ADDENDUM NUMBER ONE

**DARLA MOORE SCHOOL OF BUSINESS CONSTRUCTION – BP-2 STRUCTURE
UNIVERSITY OF SOUTH CAROLINA
STATE PROJECT NUMBER H27-6069-AC-2**

DATE OF ISSUE: January 12, 2012

SHEET NUMBER :
S-SK-006

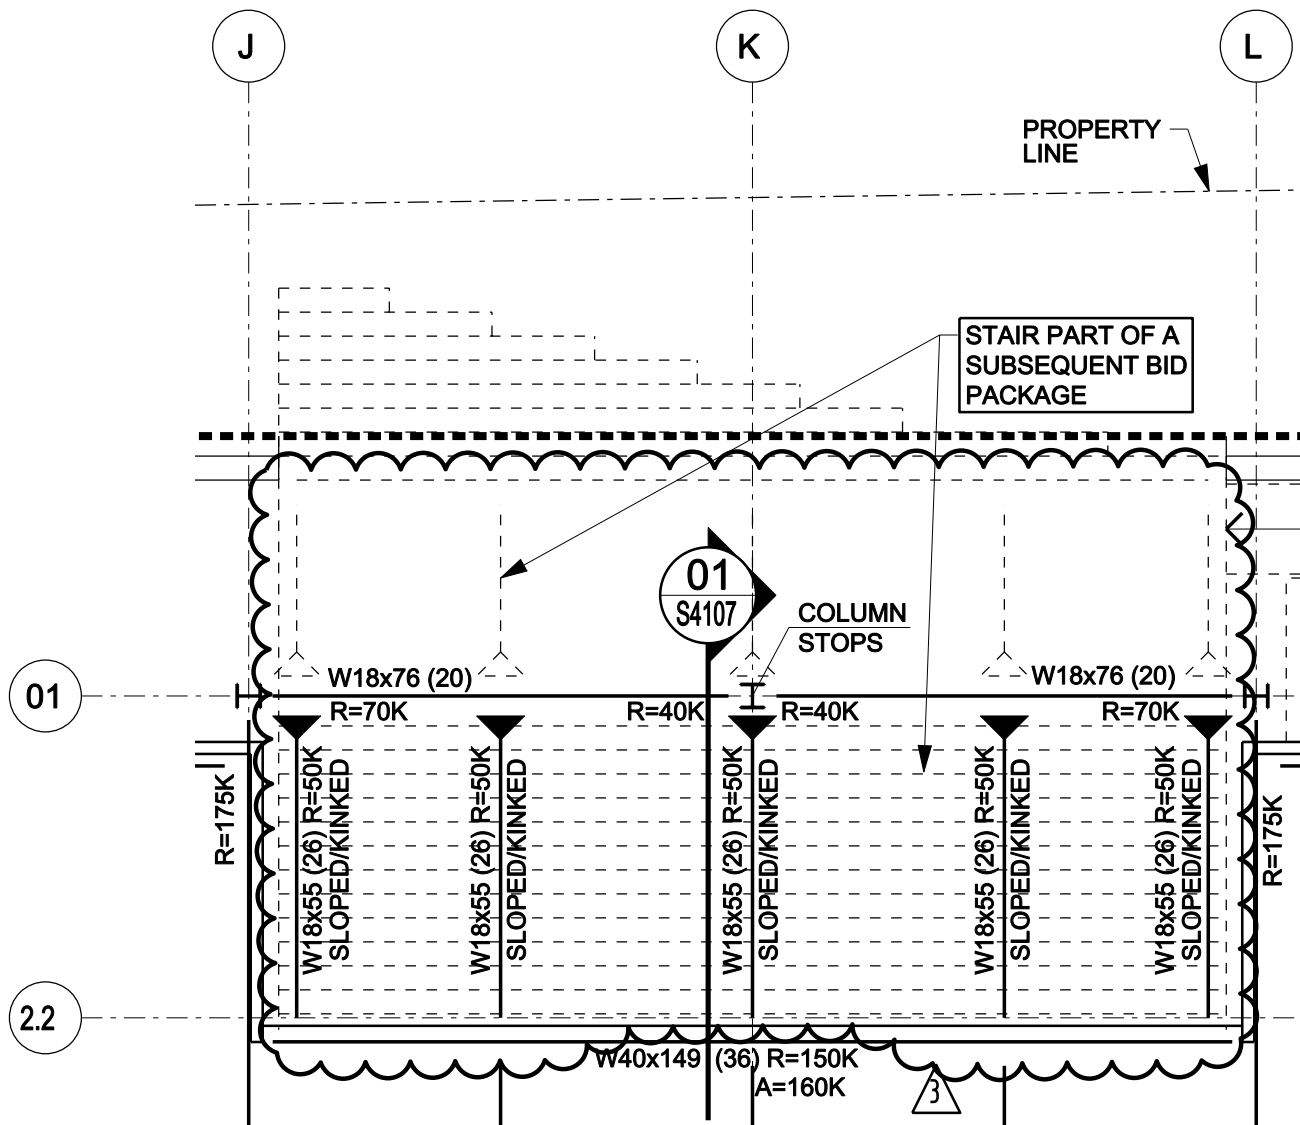
29. Plan sheet S1110D: Refer to attached sketch S-SK-006 – revised framing and added section cut at tunnel at West stair landing.
30. Plan sheet S1110F: Refer to attached sketch S-SK-001 - added footings with grade beams along Greene Street for stair and ramp support.

SHEET NUMBER :
S-SK-007

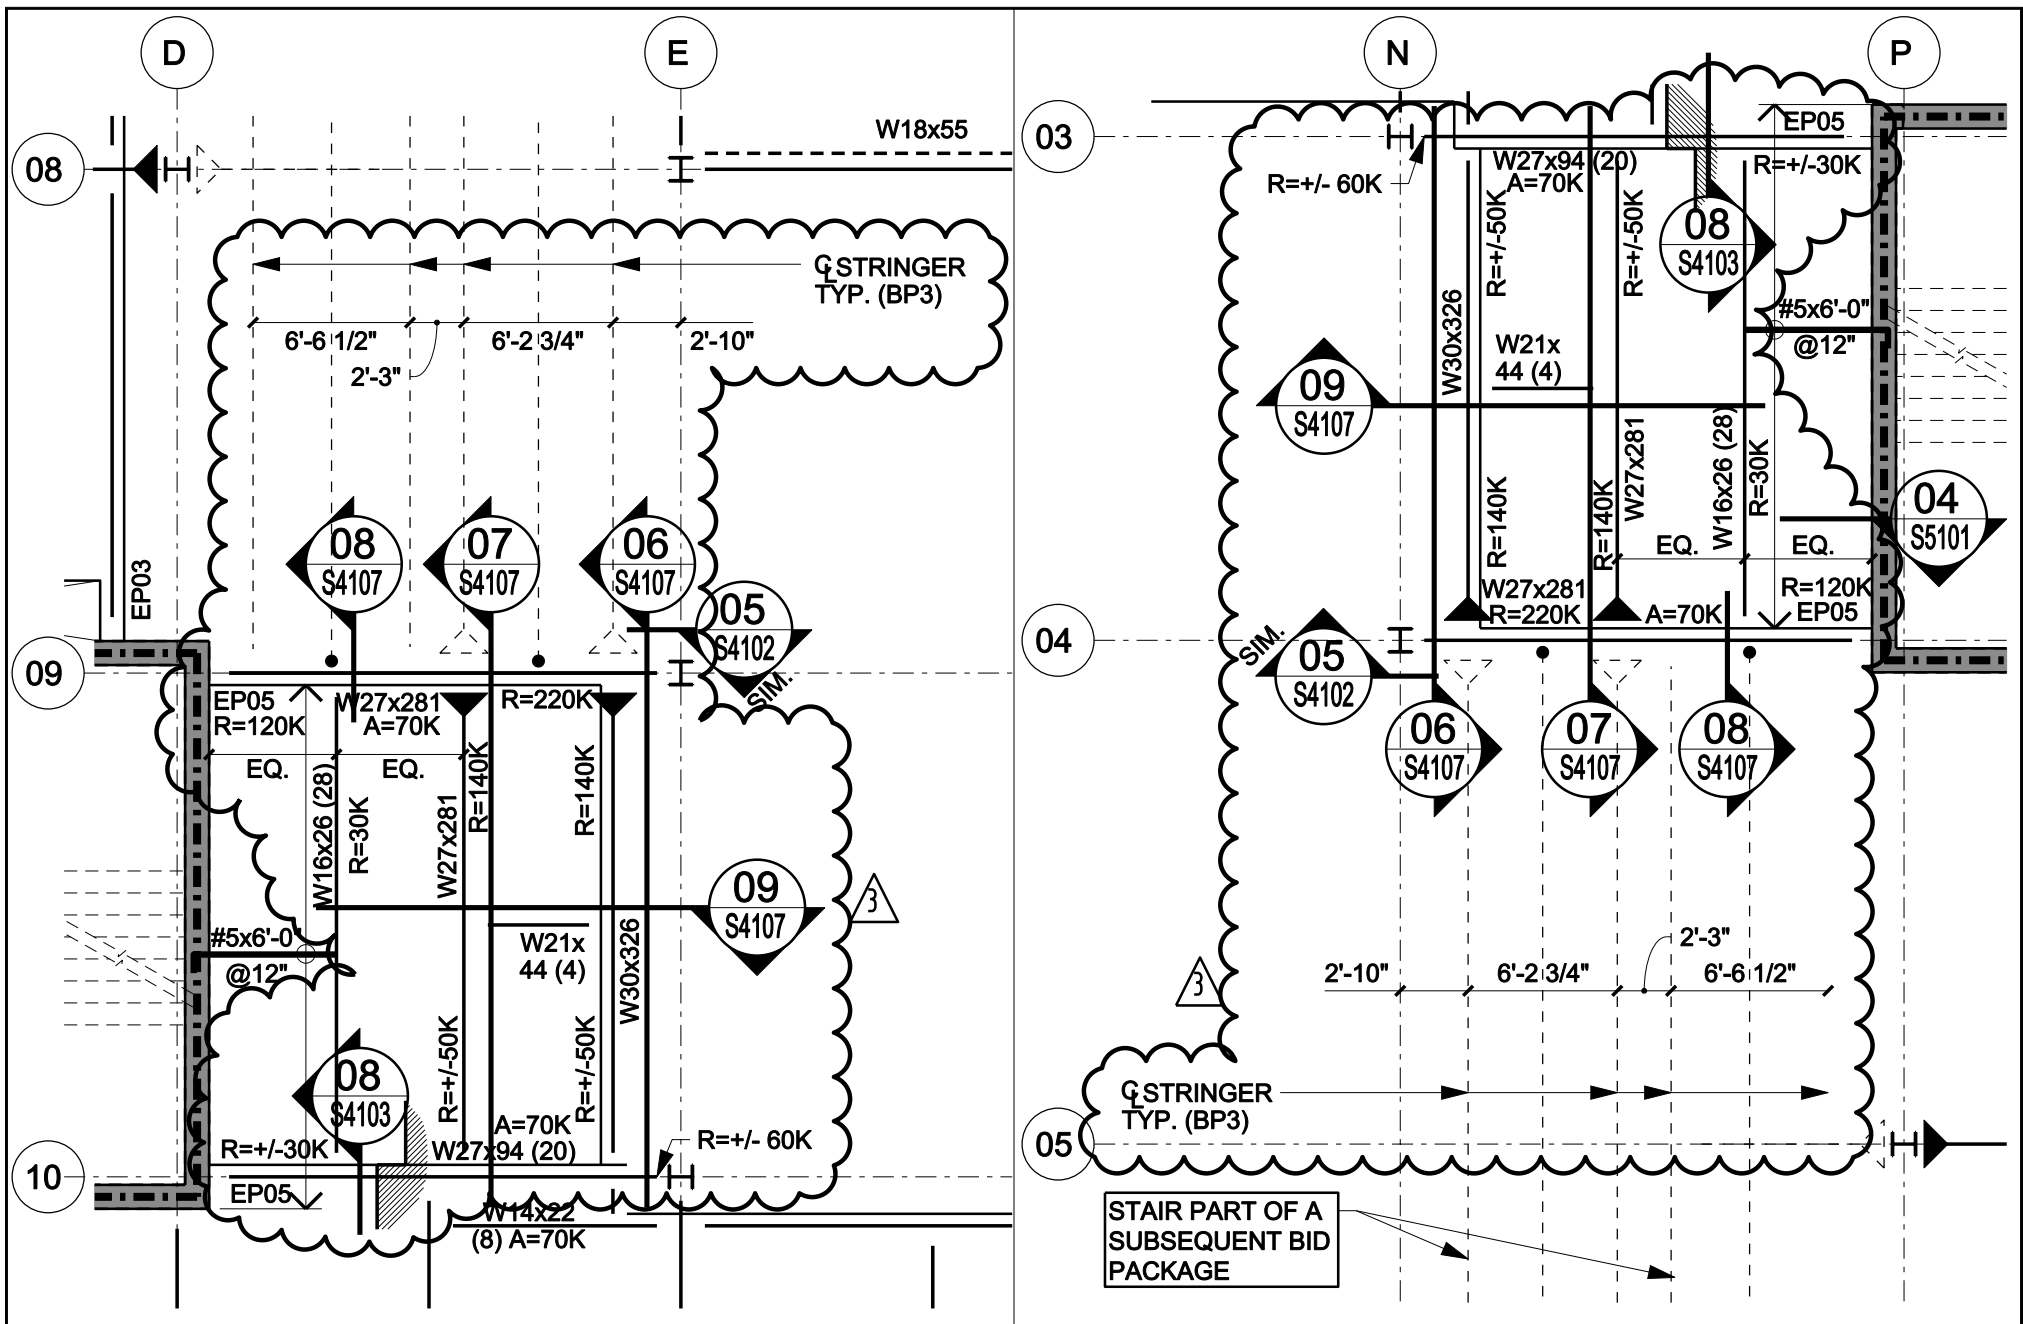
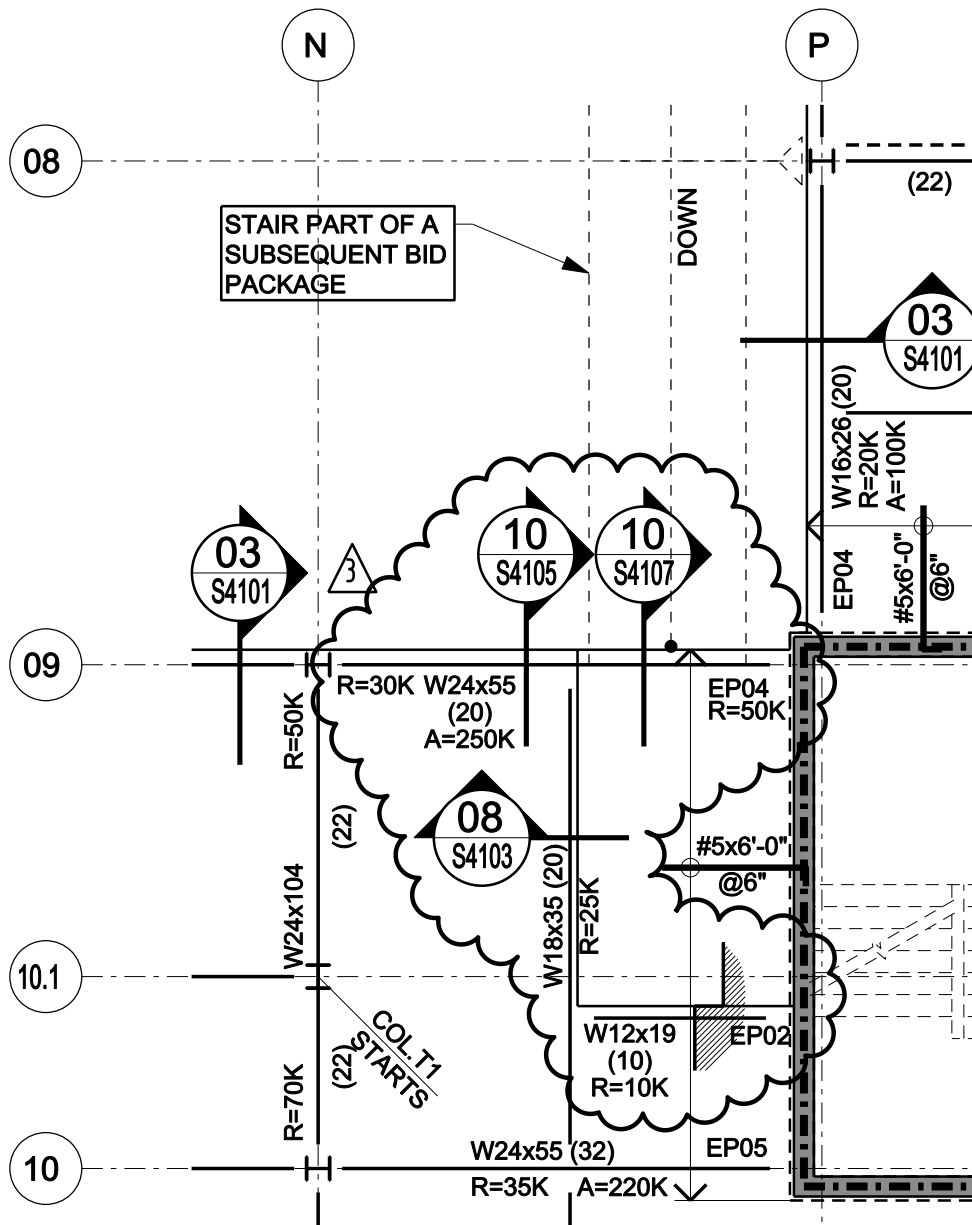
31. Plan sheet S1120A: Refer to attached sketch S-SK-007 – revised framing and added section cut for exterior stair and added column from footing to stair landing at K-01.

SHEET NUMBER :
S-SK-011

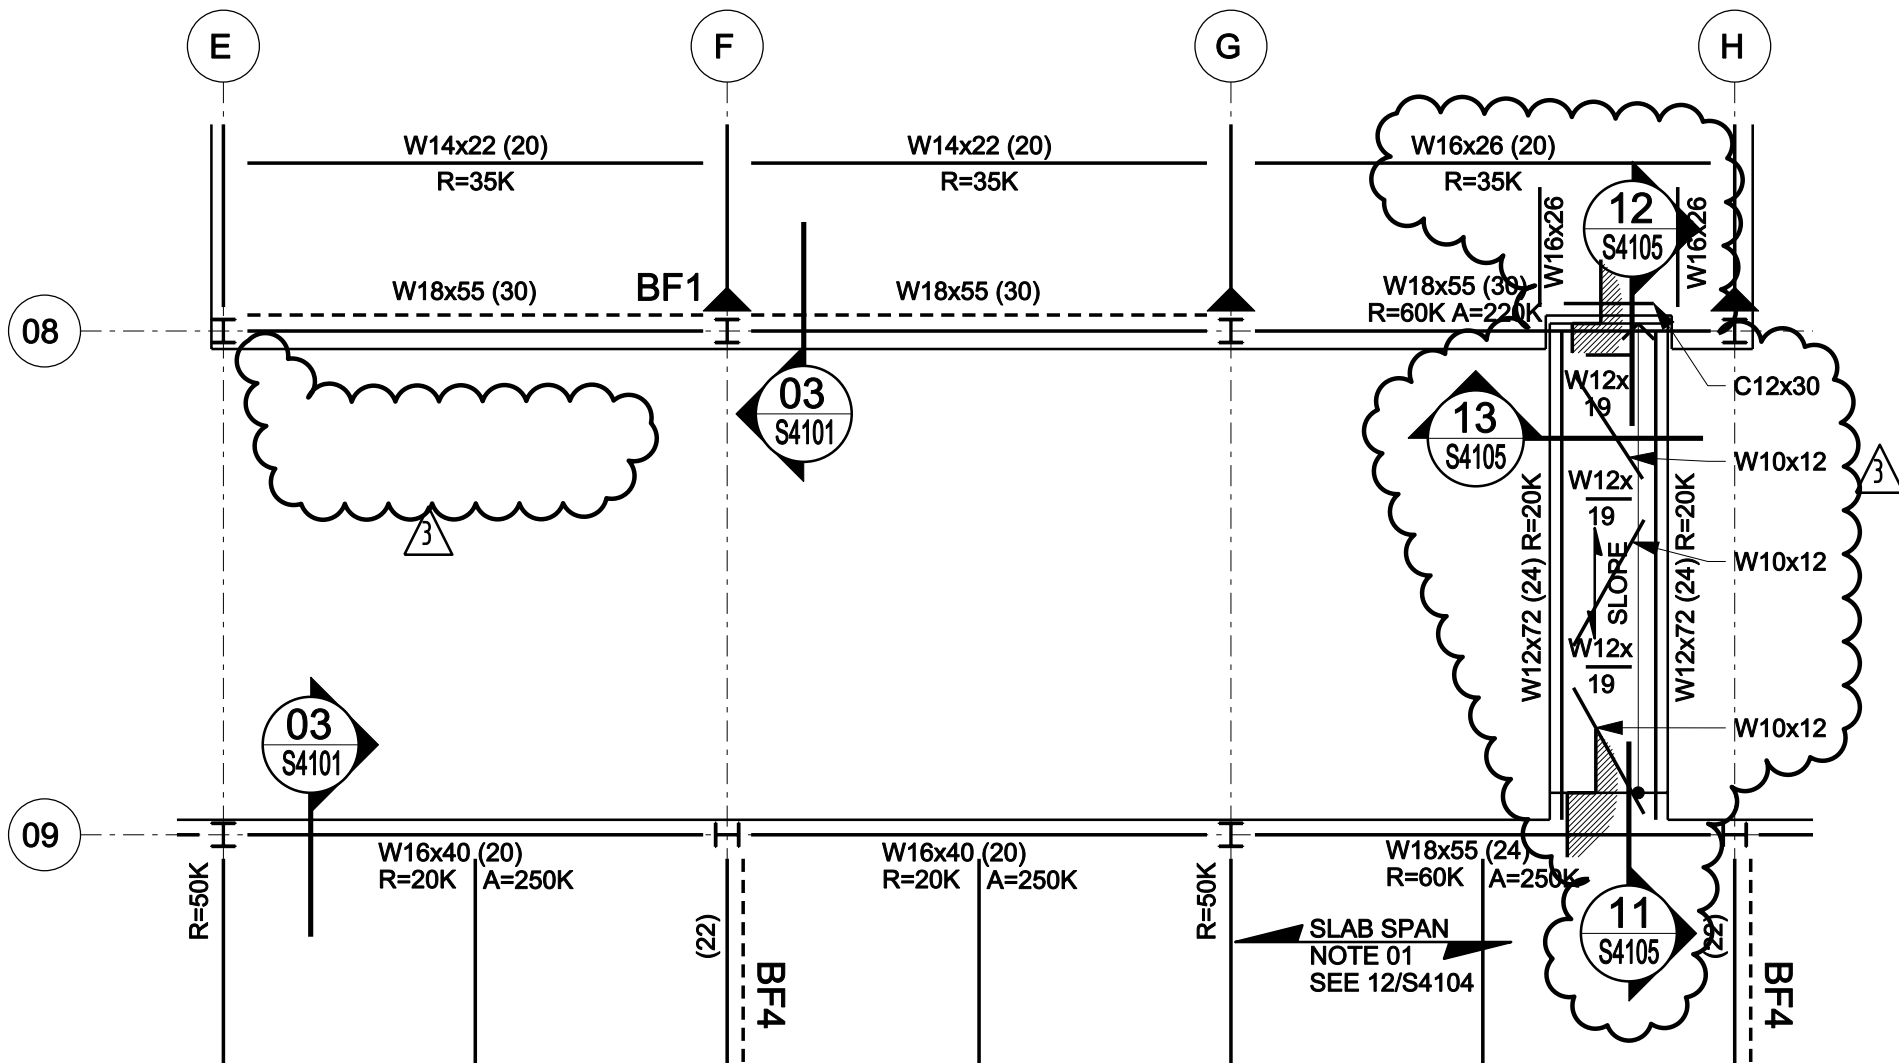
37. Plan sheet S1140B: Refer to attached sketch S-SK-011 – revised framing and added section cuts at grand stair landing.
38. Plan sheet S1140C: Refer to attached sketch S-SK-012 – revised framing and added section cuts at Pavilion Bridge. Removed note regarding concrete curb.

SHEET NUMBER :
S-SK-013

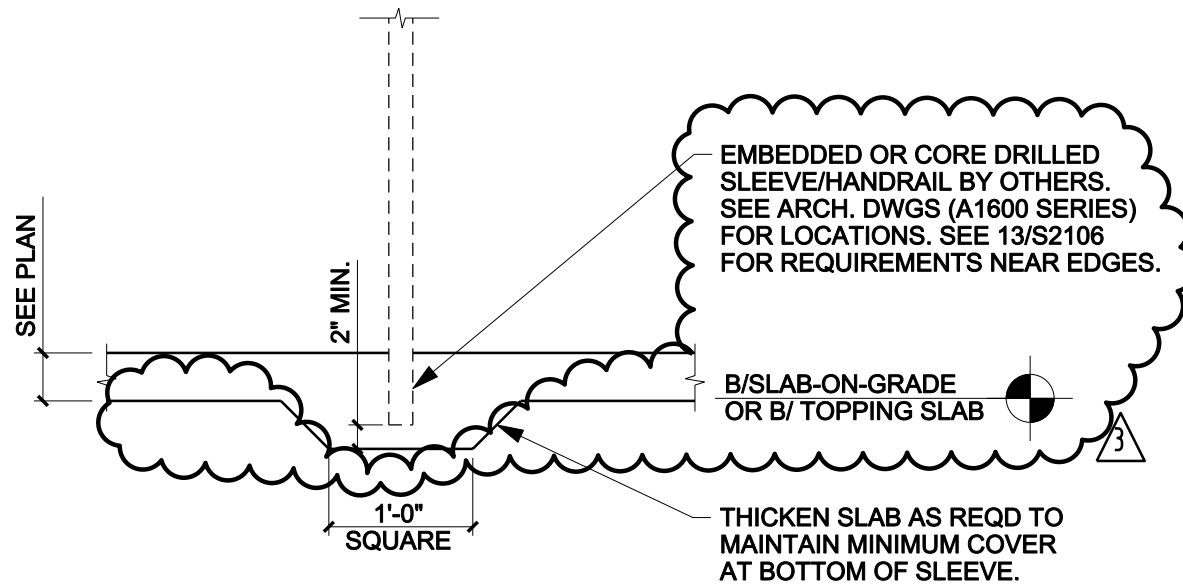
39. Plan sheet S1140D: Refer to attached sketch S-SK-013 – revised framing and added section cuts at Pavilion Bridge and grand stair landing. Removed note regarding concrete curb.

SHEET NUMBER :
S-SK-016

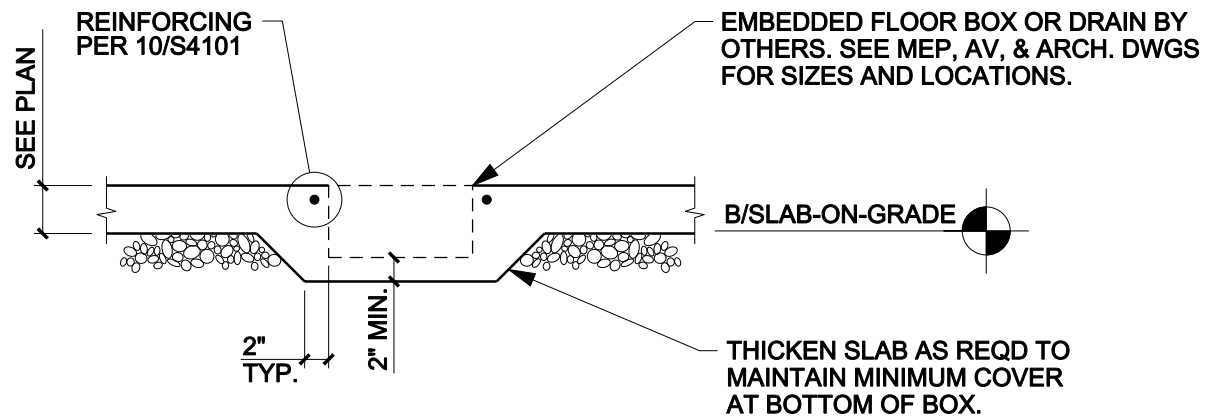
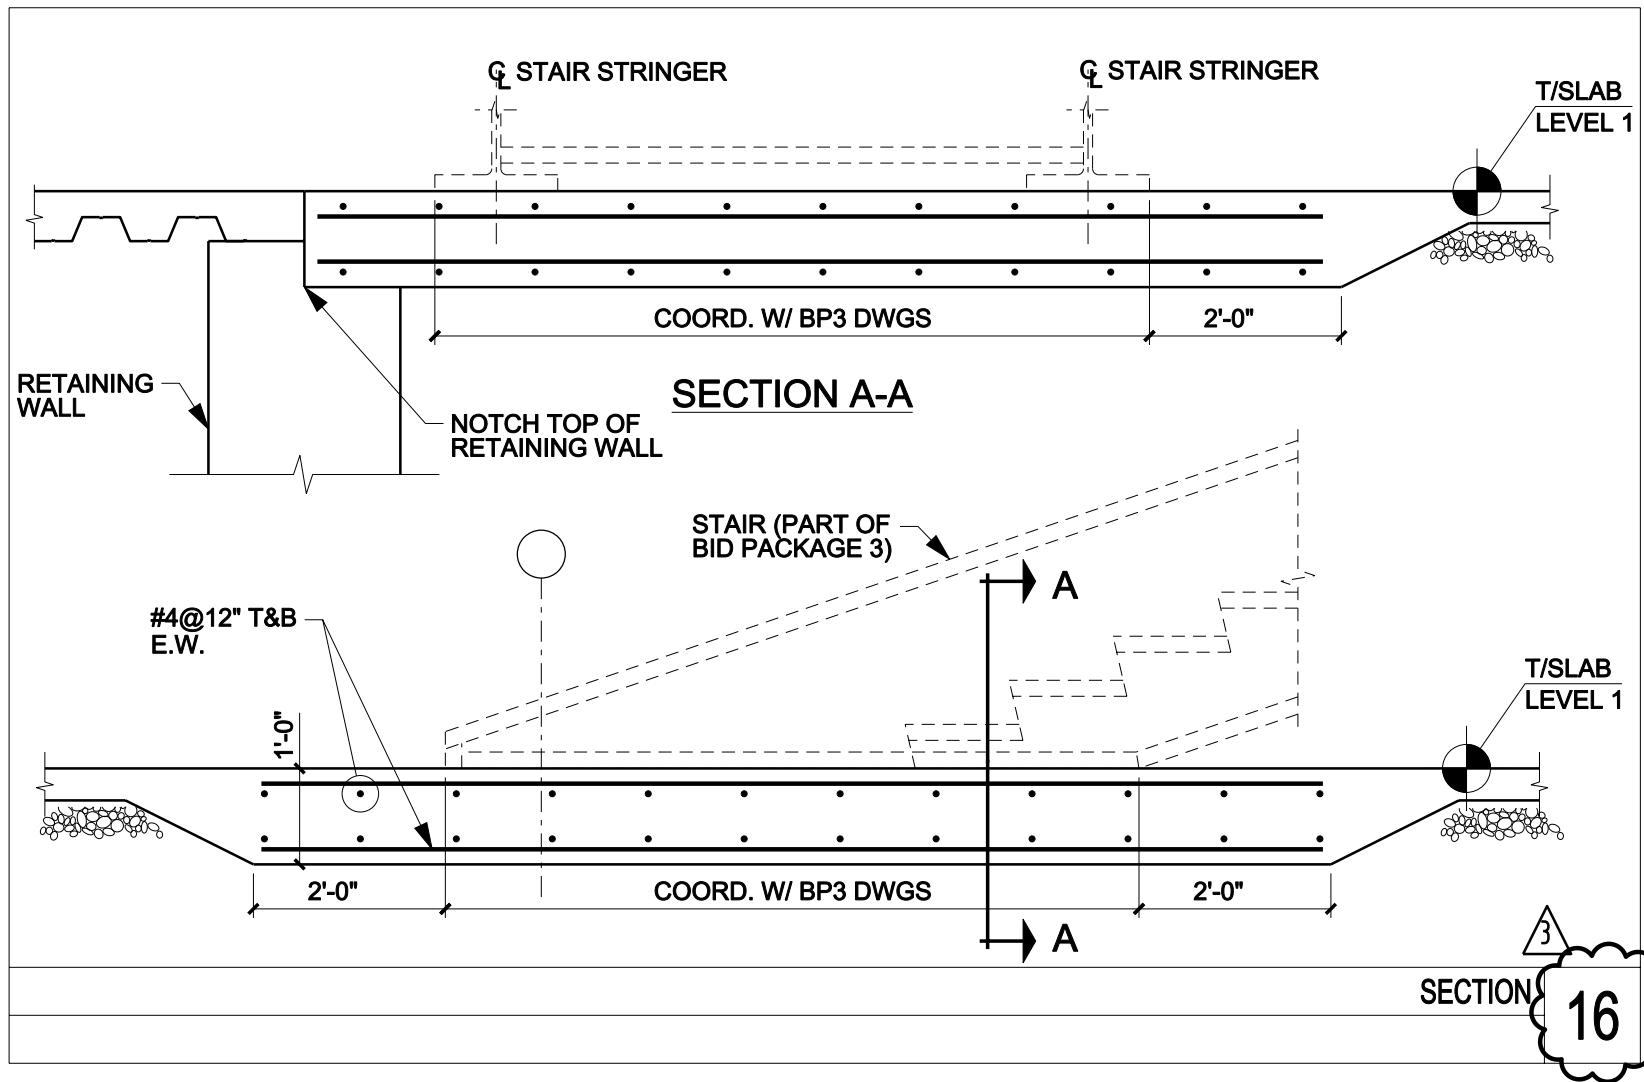
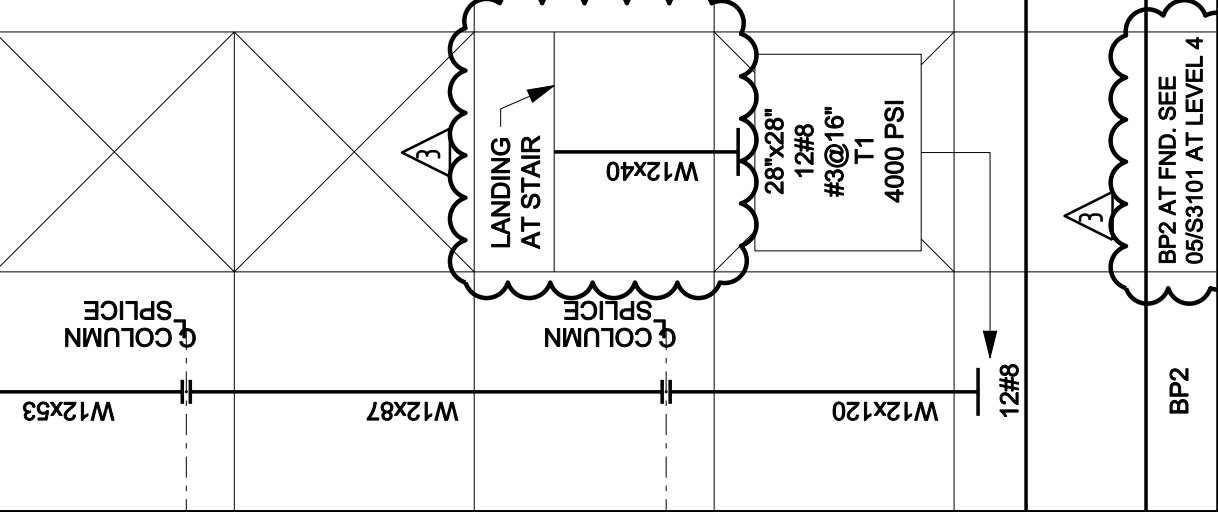
- 40. Detail sheet S2106: Refer to attached sketch S-SK-014 and S-SK-015 and S-SK-016. Revised detail 14 and added new details 15 and 16.
- 41. Column schedule sheet S3101: Refer to attached sketch S-SK-017 – revised column schedule for added column at K-01.
